Office Action Summary	Application No. 10/585,530	Applicant(s) FUJITA ET AL.	
	Examiner Mohammed Hasan	Art Unit 2873

DETAILED ACTION

Fig. 1

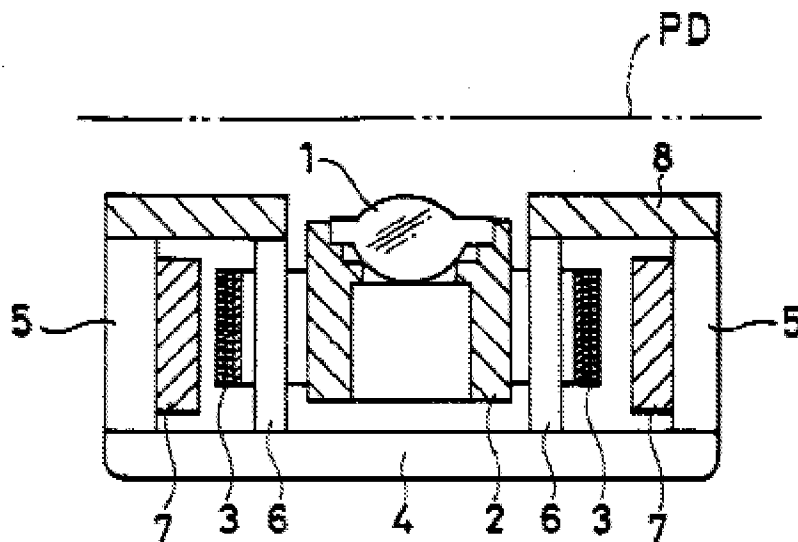
Regarding claim 1, Ohno discloses (refer to figure 1) a lens drive unit comprising: a movable lens body equipped with a lens (1) ; a drive means to move the movable lens body in an optical axis direction of the lens; a fixing body to support the movable lens body in such a manner to enable the movable lens body to move in the optical axis direction; and retaining a position of the movable lens body at both ends of an entire motion range in the optical axis direction; wherein the movable lens body is equipped with a first magnetic means (7) as the drive means; the fixing body is equipped with a second magnetic means (7) as the drive means which is placed so as to enable the movable lens body to move by one of magnetic attraction force and magnetic repulsion force caused between the first magnetic means and the second magnetic means; and furthermore, and one of the position retaining member and the movable lens body relatively moves so as to move the touching section for having the touching section touch at the movable lens body to retain the movable lens body at the middle position so that the number of retaining positions of the movable lens body increase from both the two ends of the entire motion range (column 3, lines 40-65).

Regarding claim 2, Ohno discloses, wherein one of the position retaining member and the movable lens body rotates relatively by using the optical axis as a rotating center so as to move the touching section for having the touching section touch at the movable lens body to retain the movable lens body at the middle position (as shown in

Regarding claim 4, Ohno discloses wherein the first magnetic means (7) is materialized by one of a drive magnet and a drive coil; the second magnetic means (7) is materialized by the other side elements of a couple of drive magnets and a couple of drive coils which are placed separately at both sides of the first magnetic means in the optical axis direction; the middle position is materialized under a positioning condition in which the first magnetic means is in proximity to the second magnetic means; and at the middle position, the movable lens body is touched to the touching section under forced condition, by magnetic attraction force between the drive magnet and a back yoke of the drive coil (as shown in figure 1).

Regarding claim 5, Ohno discloses wherein the position retaining member is located at a side of an image pickup device (as shown in figure 1).

Regarding claim 6, Ohno discloses wherein the touching section retains the movable lens body at the middle position by touching at an end surface in the optical axis direction of the movable lens body (as shown in figure 1).

Regarding claim 7, Ohno discloses wherein the position retaining member gets moved so as to move the touching section for having the touching section touch at the movable lens body to retain the movable lens body at the middle position (as shown in figure 1).
